Solar Energy Development PEIS

To: Linda Resseguie, BLM Solar PEIS Project Lead, Argonne National Laboratory
From: Utah Clean Energy
Subject: Comments on Solar Energy Development Draft Programmatic Environmental Impact Statement
Date: May 2, 2011

Comments by the Amargosa Conservancy on the Draft Programmatic Environmental Impact Statement

Figure 1. Concentrating Solar Resource of the United States. National Renewable Energy Laboratory. 2008. (DNI scale: 1.3 kWh/m²/day to 8.3 kWh/m²/day)

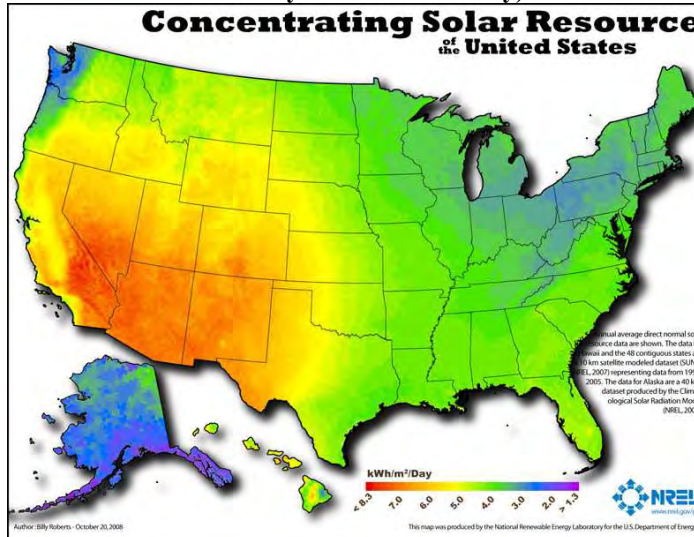
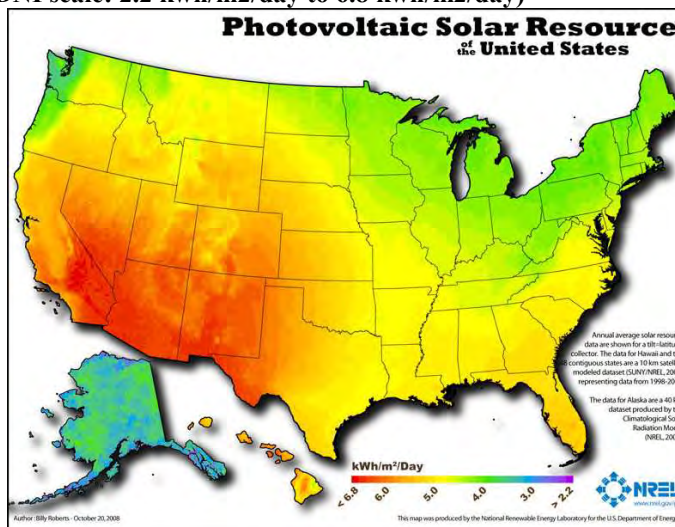
resource potential developed by the National Renewable Energy Laboratory indicate that PV resource potential is greater at lower DNI's, as compared with CSP (see figures 1 and 2).

If the purpose of the screening criteria is to “allow time and effort to be directed to those projects which have the greatest chance of success,”¹³ BLM should consider the availability of the solar resources applicable to the solar technology with the greatest chance of development. Therefore, we recommend consultation with solar developers and the National Laboratories to develop an appropriate insolation screening level in order not to preclude cost-effective PV development.
